Subject: Keene Road Disposal Class III Landfill
Application For Class III Landfill Permit
Received August 7, 2000

Subject: Keene Road Disposal Class III Landfill
Application For Class III Landfill Permit
Submitted January 26, 2000

KEENE ROAD DISPOSAL CLASS III LANDFILL
IMPERMEABLE BARRIER LAYOUT

NWPC

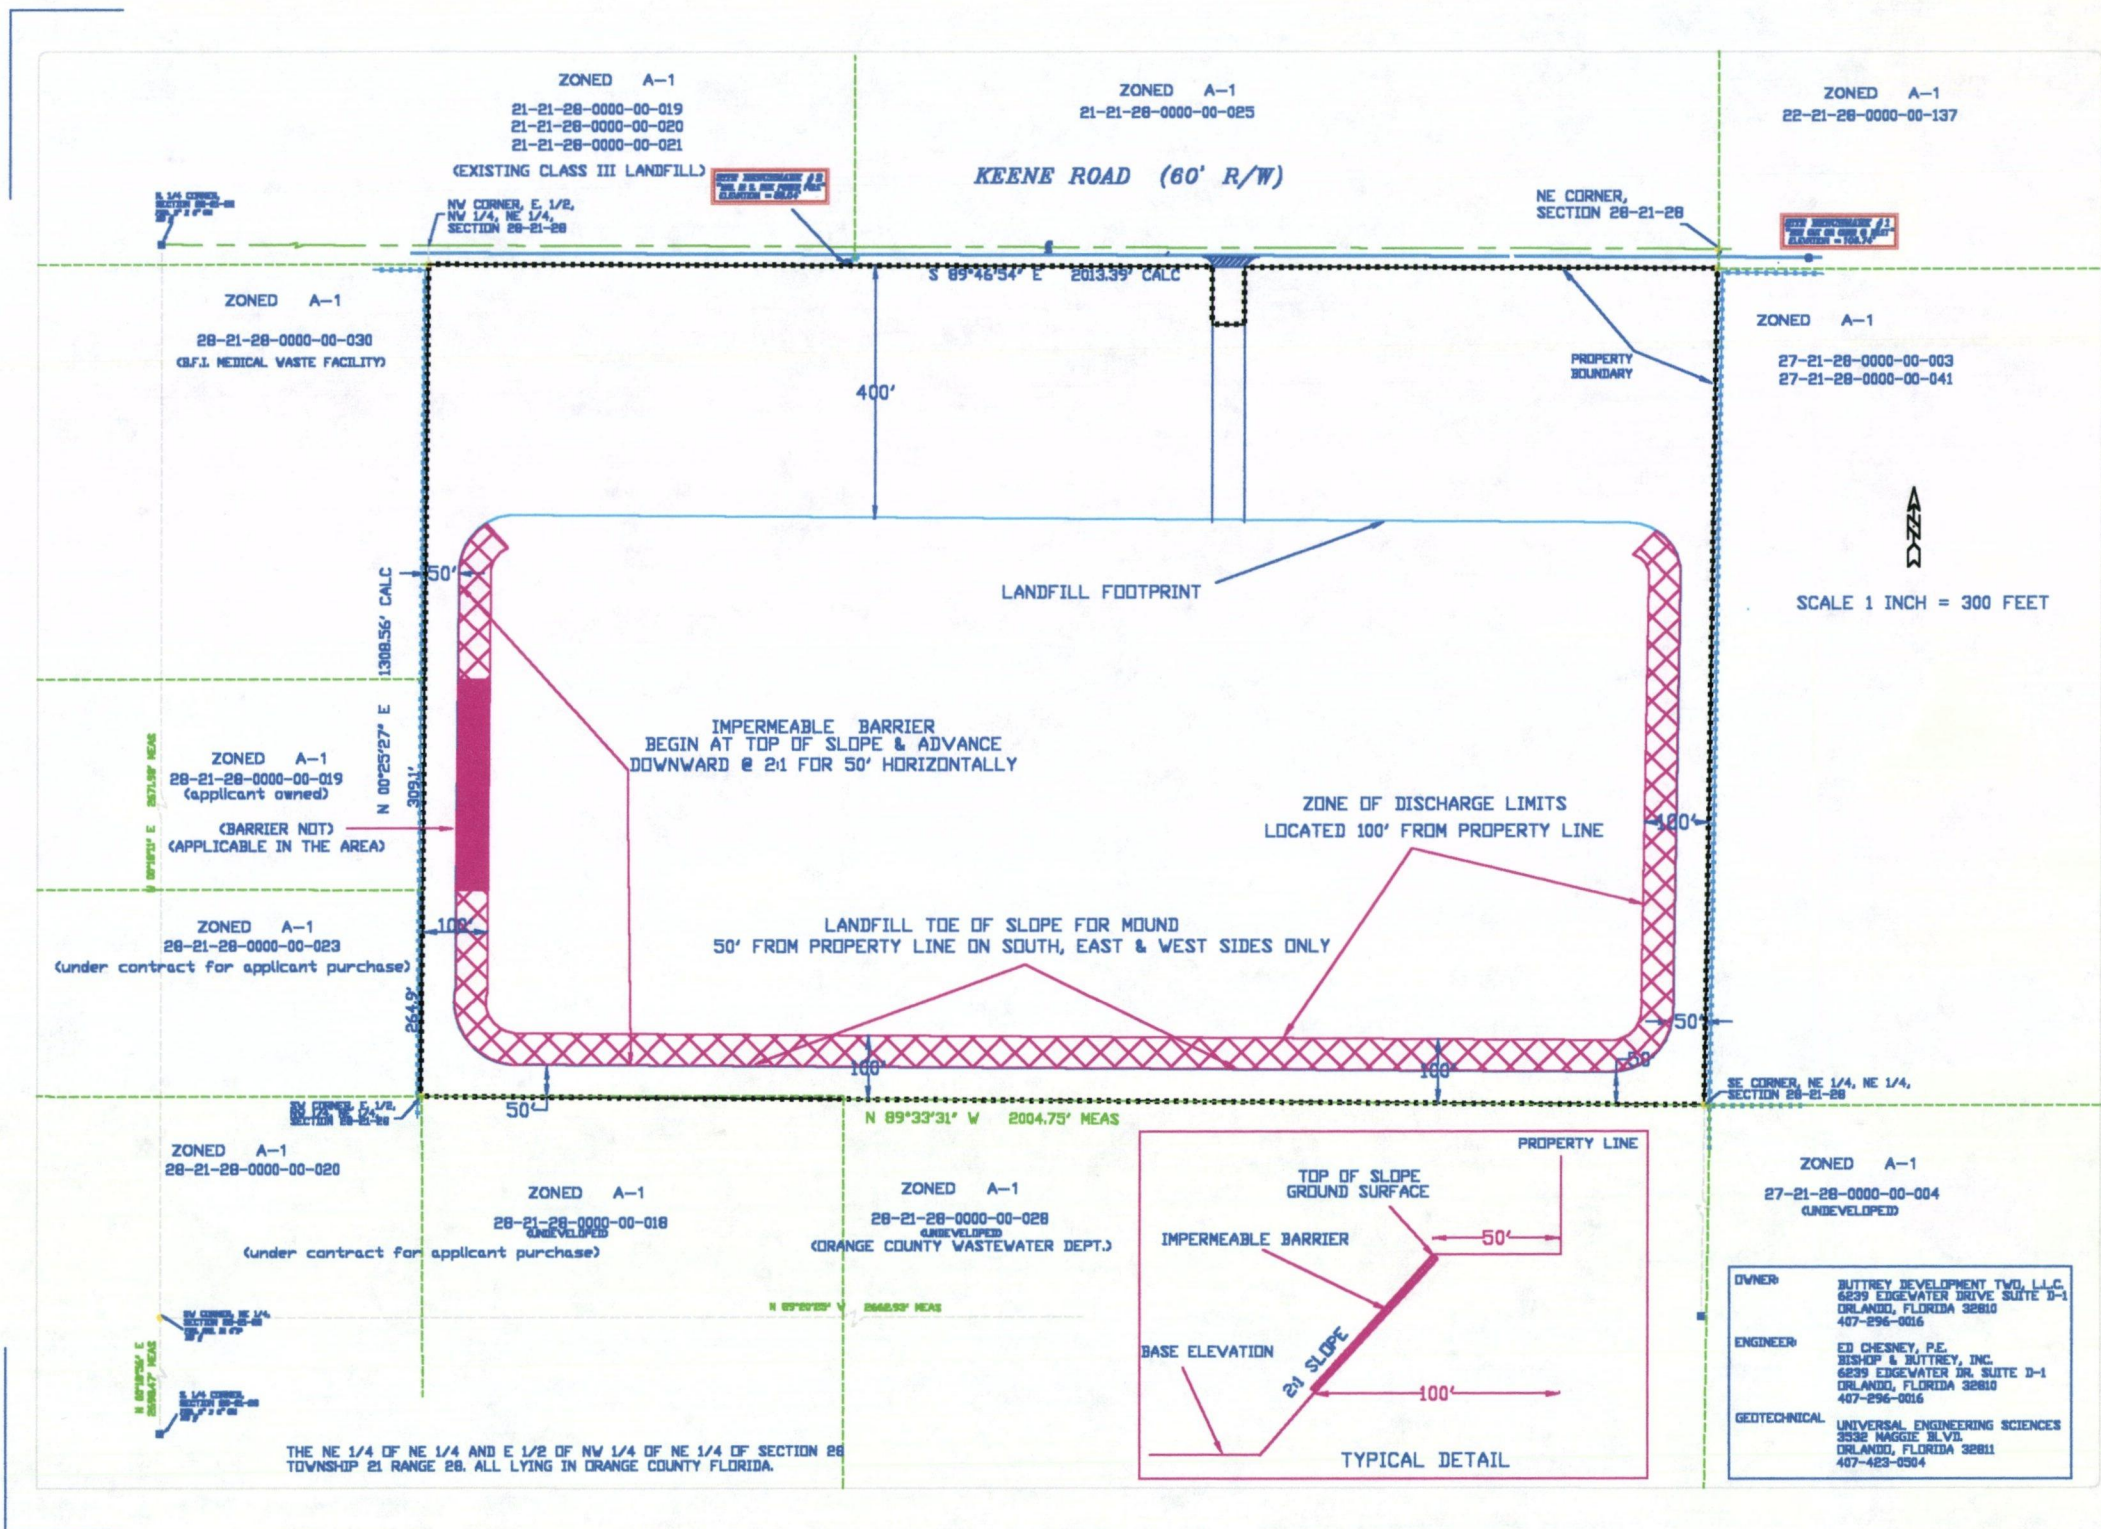
Comment 39: The clay plug concept is unacceptable. The plug cannot be anchored continuously. Following the review of cross sections A-E, it is determined that laboratory tested confining soils are not located in all areas to allow a complete anchor. Perched water contained in soils adjacent to the landfill base grades in the northwest section of the landfill is expected to continue to seep into the landfill following recharge. Sump areas are created in order to allow anchoring into the confining soils. There is a lack of interim stormwater controls. It is doubtful that a 10^{-5} cm/sec liner permeability specification will prevent the groundwater from exceeding MCL standards when tested.

Clear evidence that a bottom liner is unnecessary is not provided. Please propose a design that provides a continuous bottom liner having a maximum permeability of 10^{-7} cm/sec.
